PROJECT:  
**NEW O'REILLY AUTO PARTS STORE**  
**N. MARKSHEFFEL ROAD**  
**COLORADO SPRINGS, CO #11**  
**SITE DEMOLITION PLAN**

COMM #	4369
DATE:	10-11-19
REVISION DATE:

# SDP\_V1.pdf Markup Summary

**1 SITE UTILITY PLAN**  
C3.1 SCALE: 1" = 20'-0"

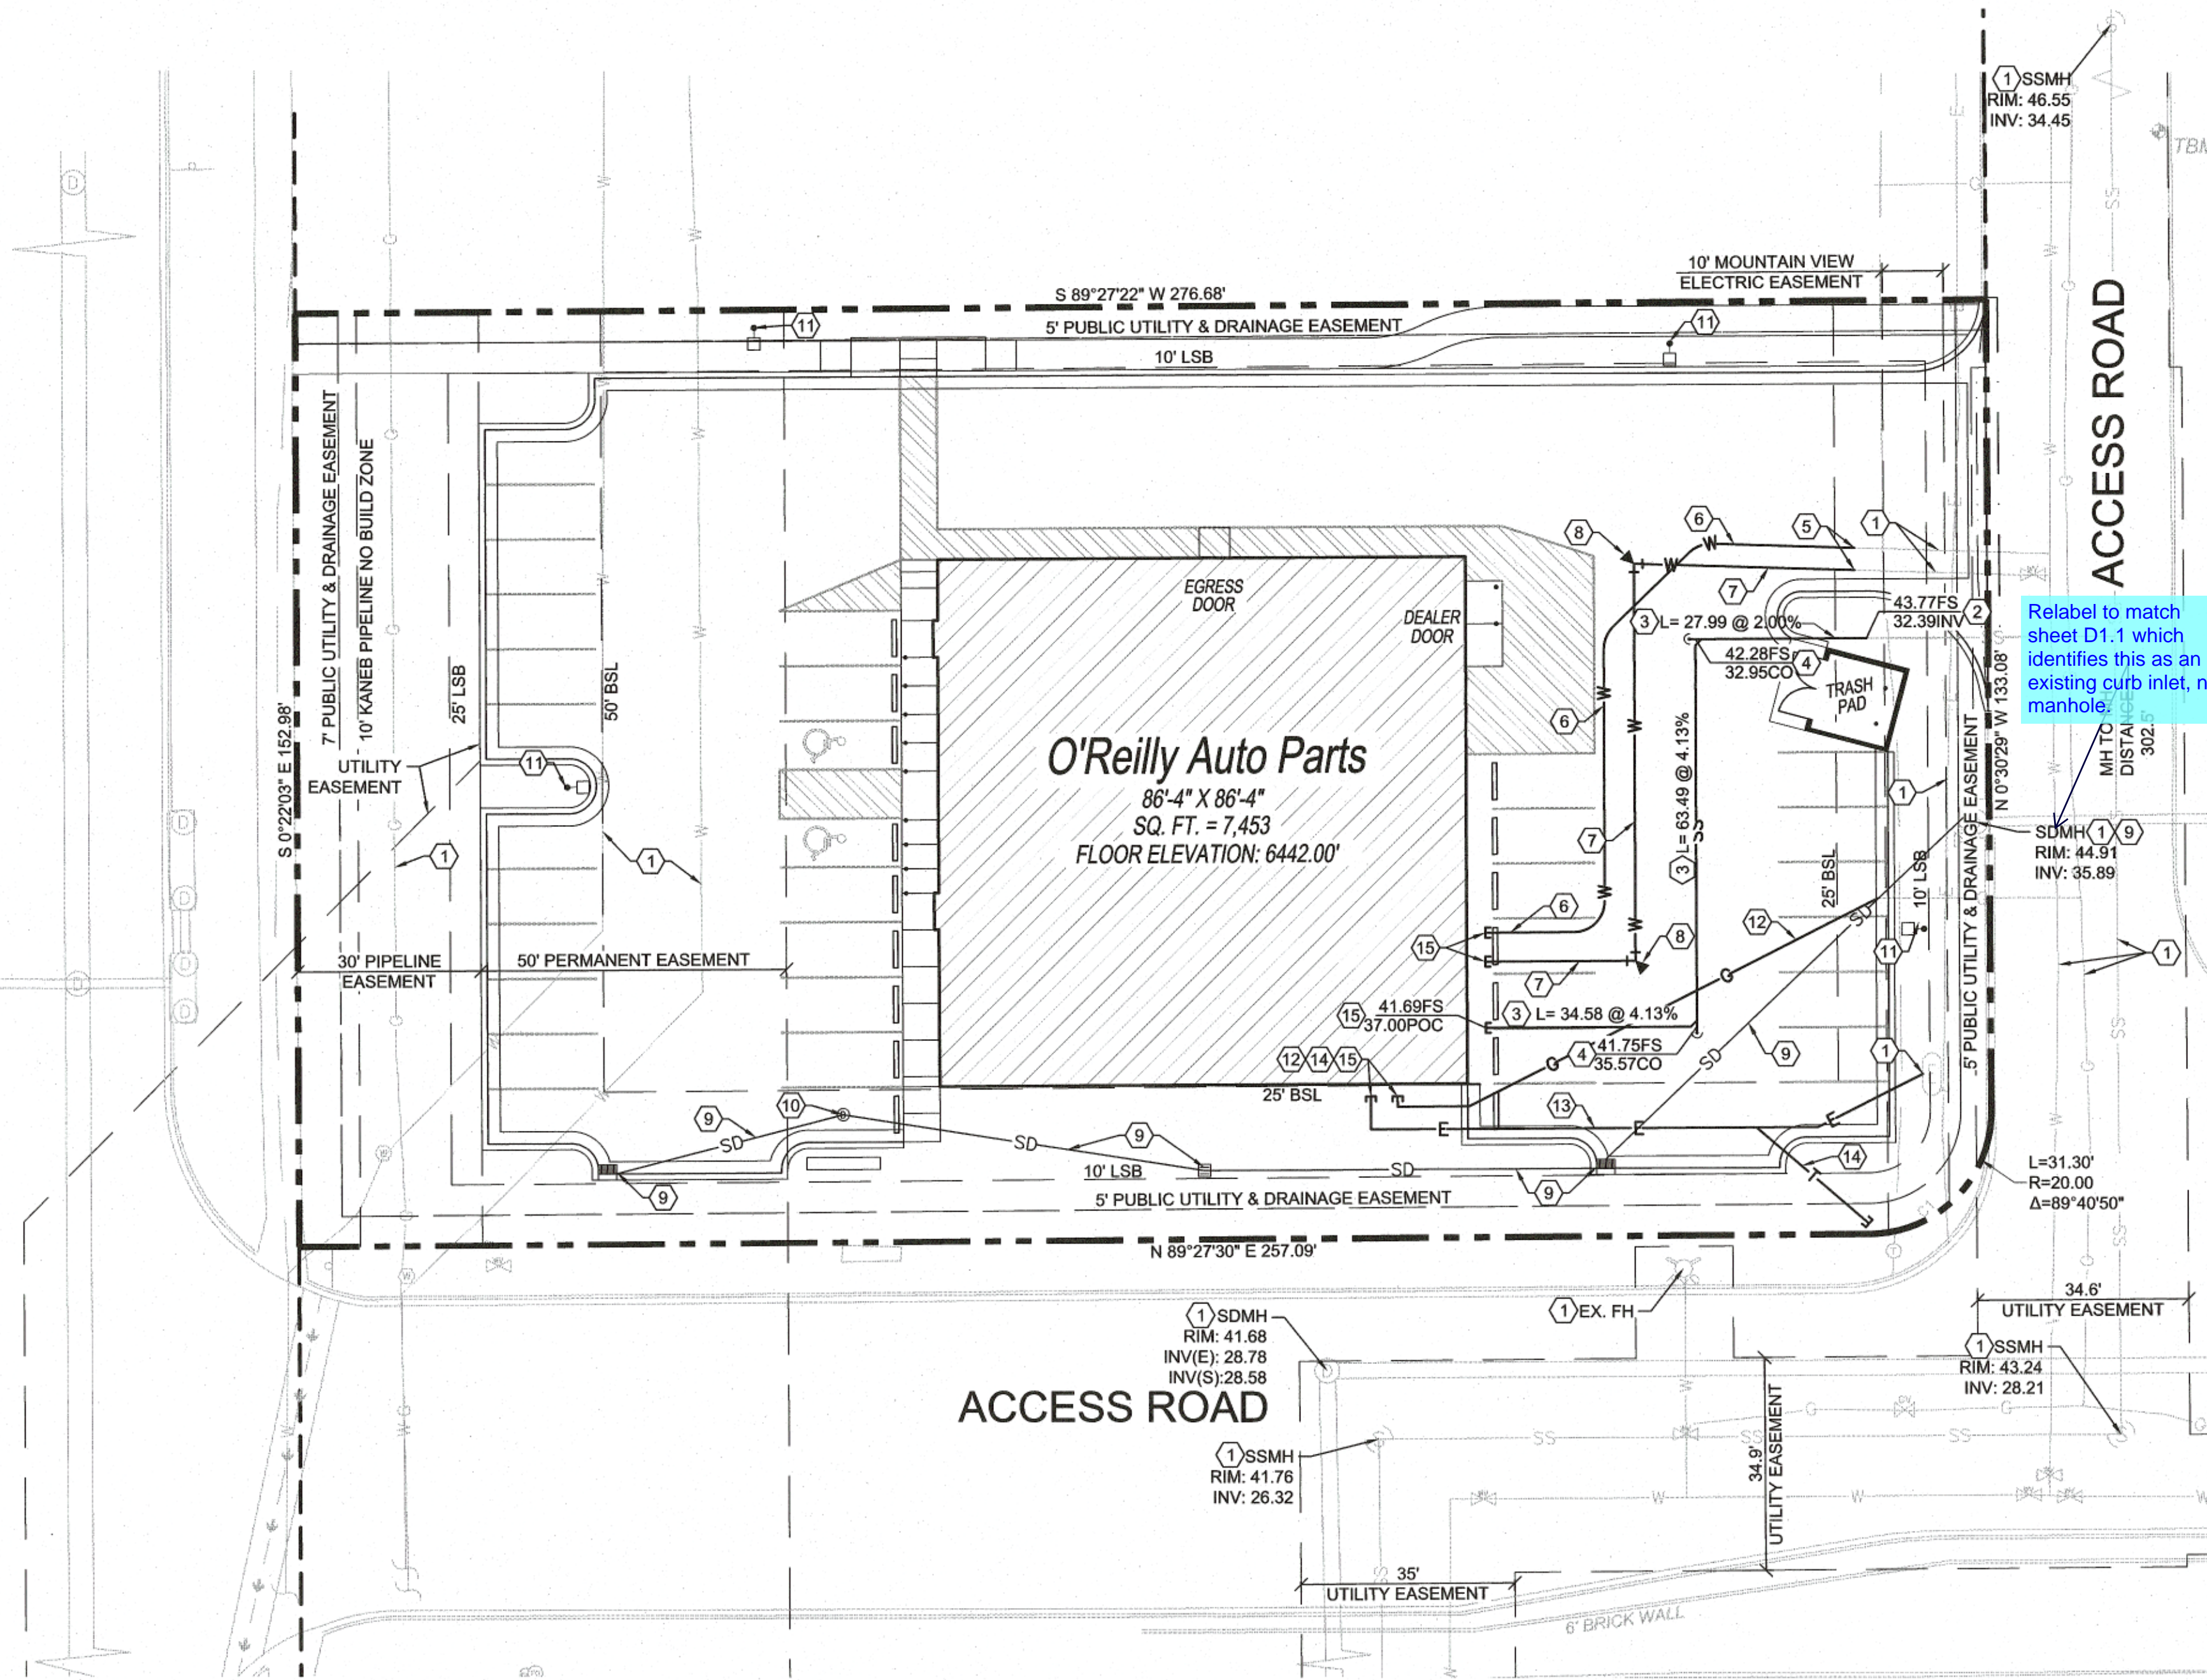
**Subject:** Callout  
**Page Label:** 6  
**Lock:** Locked  
**Author:** dsdlaforce  
**Date:** 2/10/2020 9:10:10 AM  
**Status:**  
**Color:** ■  
**Layer:**  
**Space:**

Relabel to match sheet D1.1 which identifies this as an existing curb inlet, not manhole.
